DUKE POWER COMPANY

Subject: McGuire Nuclear Station  
Docket Numbers 50-369 and 50-370  
Reply to Request for Additional Information  
Regarding Unresolved Item 50-369,-370/87-13-01

RESPONSE TO REQUEST FOR  
ADDITIONAL INFORMATION REGARDING RADIOIODINE  
AND PARTICULATE SAMPLING AT THE MCGUIRE  
NUCLEAR STATION, DOCKET NOS. 50-369 AND 50-370

Plan of Unit Vent — Layout of  
Sample Probe Taps for Verification  
of General Atomic Design

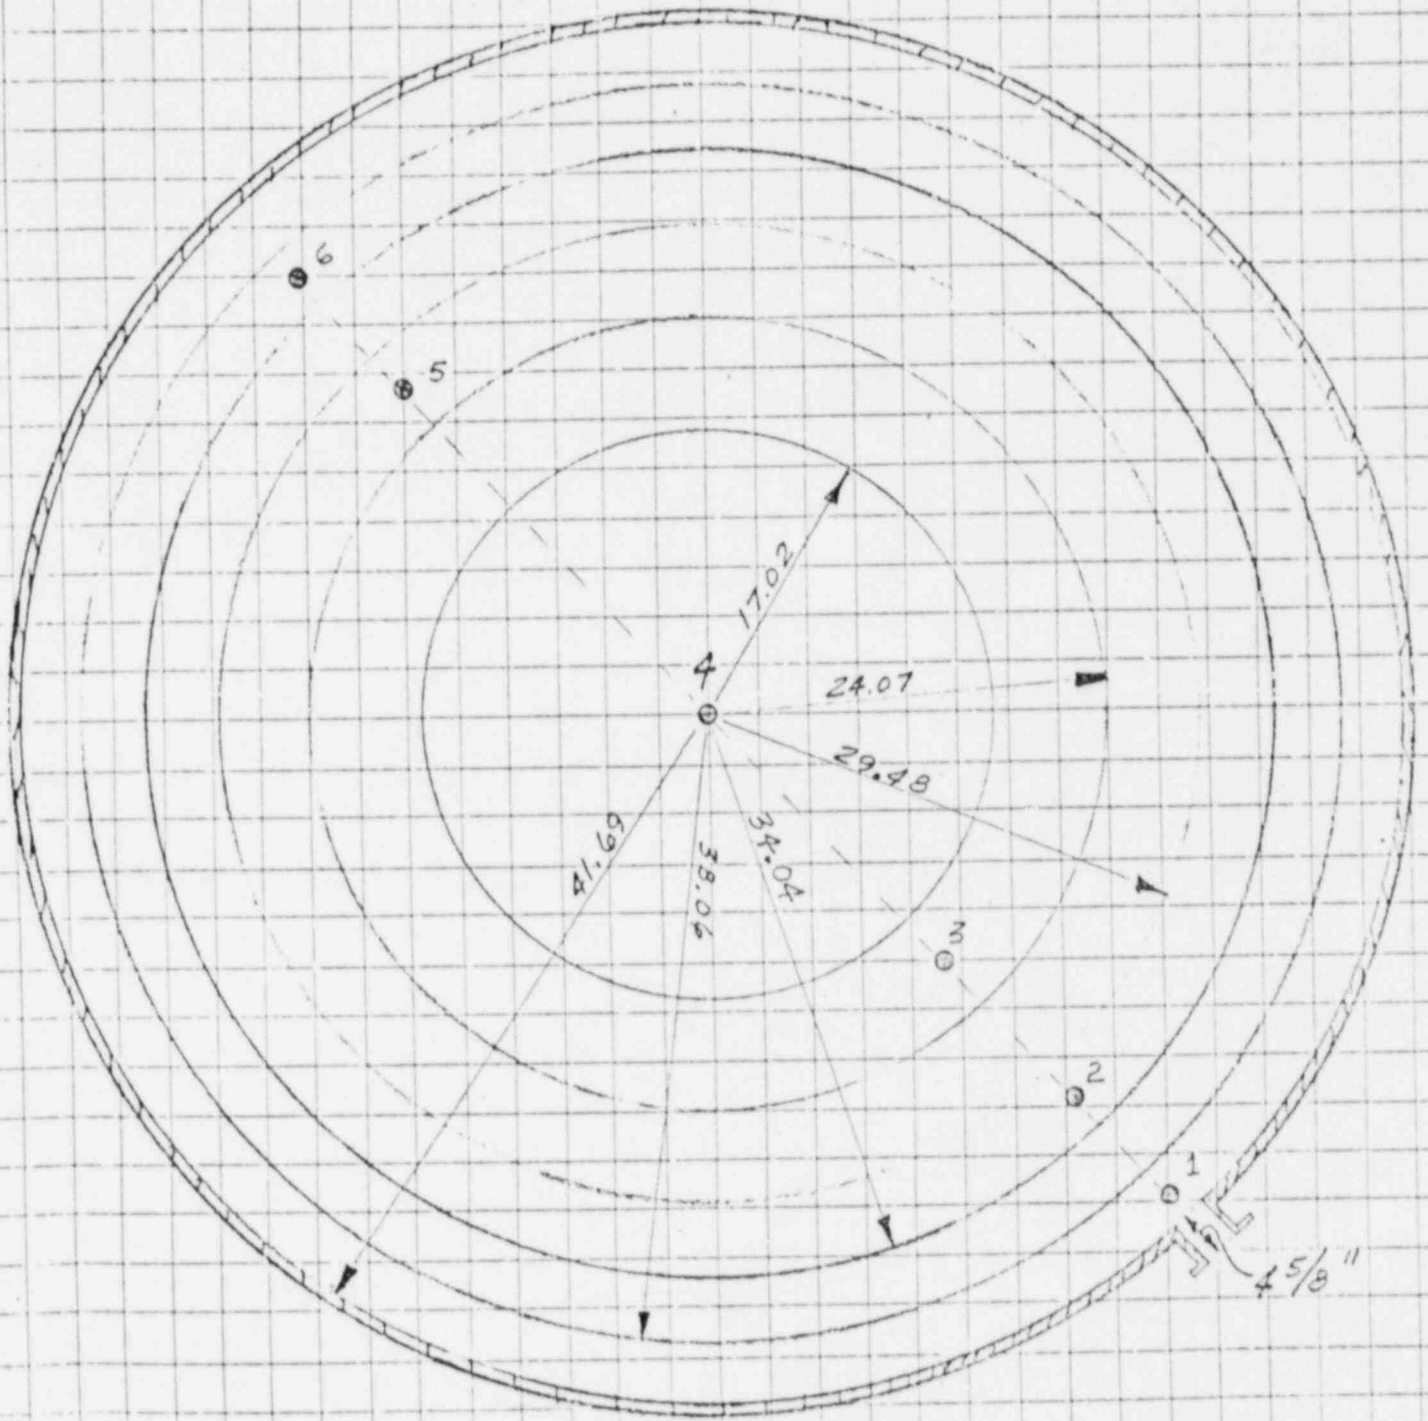
Based on the schematic of the unit vent on the previous sheet, determine the six (6) tap locations referenced to the wall of the unit vent.

Per Detail B of MC-1091-12, the flange supplied by D.P. Co for mounting the sample probe is mounted such that flange face is  $4\frac{5}{8}$ " from unit vent inside surface. To verify dimensions on Gen Atomic dwg. ELE321-3010, which are referenced to the flange face, the dimensions on the preceding page must be increased by  $4\frac{5}{8}$ ."

As evidenced in the two rightmost columns above, the tap locations selected by the vendor are essentially in compliance with Section A3.2 of Appendix A of ANSI-N13.1-1969. This aspect of the probe design is considered satisfactory.

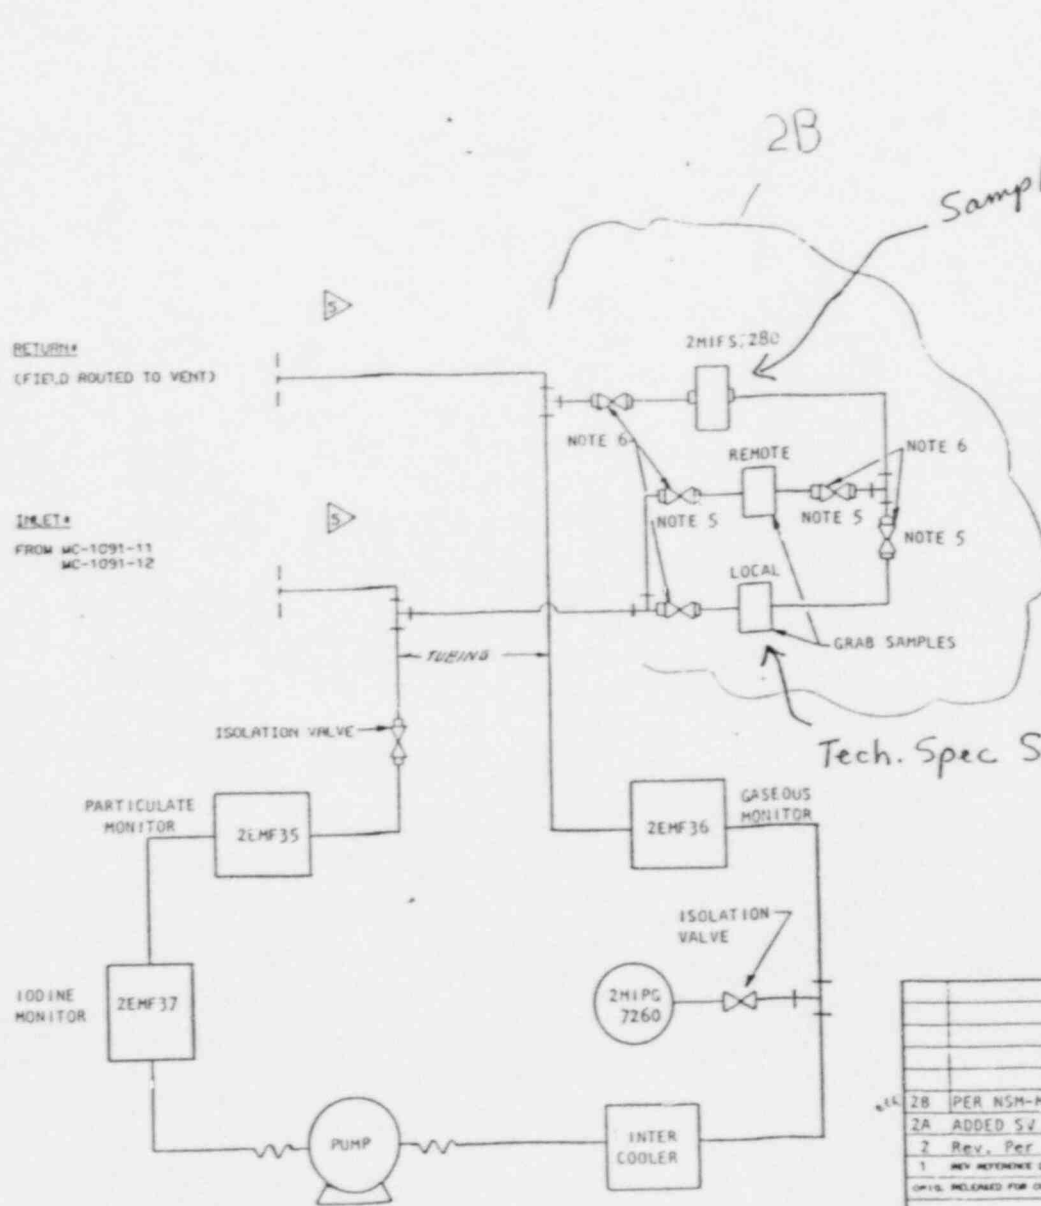
2. Provide a description of Nuclear Station Modification (NSM) MG-1-1623 and MG-2-0588.

3. a. Describe the equipment and procedures that will be used to continuously sample gaseous effluents post LOCA.

The NSMs in question will provide additional tubing to allow remote particulate and iodine grab sampling, post LOCA. Any sections of tubing exposed to a cold environment will be insulated and heat traced. All inlet tubing will have a minimum of plate out locations such as 90 degree elbows, etc. Attachment 2 provides a sketch of the grab sampling equipment.

To provide continuous sampling under post LOCA conditions a remote sampler is being installed per the previous discussed NSMs. The remote sampler will sample from the unit vent stack sampling point currently in use. Attachment 2 provides a sketch of the grab sampling equipment.
